Interactive comment on “Global emissions of fluorinated greenhouse gases 2005–2050 with abatement potentials and costs” by Pallav Purohit and Lena Höglund-Isaksson

Received and published: 28 November 2016

Referee #3 (A. McCulloch)

Figure 10: Comparison of GAINS baseline scenario with other F-gas business-as-usual scenarios

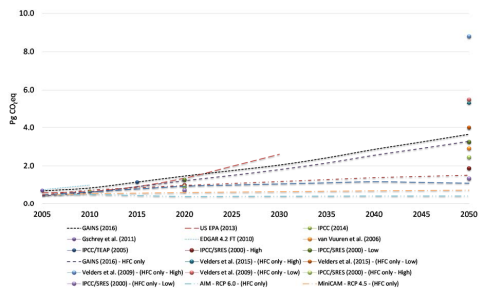
4. The paper contains a section on comparison with other studies but fails to mention the Representative Concentration Pathways used by IPCC to describe the future con-

centrations of all greenhouse gases. The baseline scenario given in this paper results in emissions between two and three times higher than the largest of the RCP scenarios (RCP8.5). At the very least this discrepancy needs to be addressed and sufficient reasons given to enable the scenario derived for this paper to be used in the broader context of future greenhouse gas emissions. Admittedly, the impact of the compounds covered by this paper amounts to less than 2% of the total impact of all greenhouse gases in the future, but although their effect is small, it is essential that it is placed accurately in the context of total greenhouse gas impacts.

Authors' Response: Yes, thank you this is a very good suggestion. We have now included the RCP scenarios in our comparison in Figure 10 of the revised manuscript using data from IIASA's RCP database. In addition, in the Introduction (Section 1) we also relate the importance of F-gases to total anthropogenic greenhouse gas emissions as suggested.
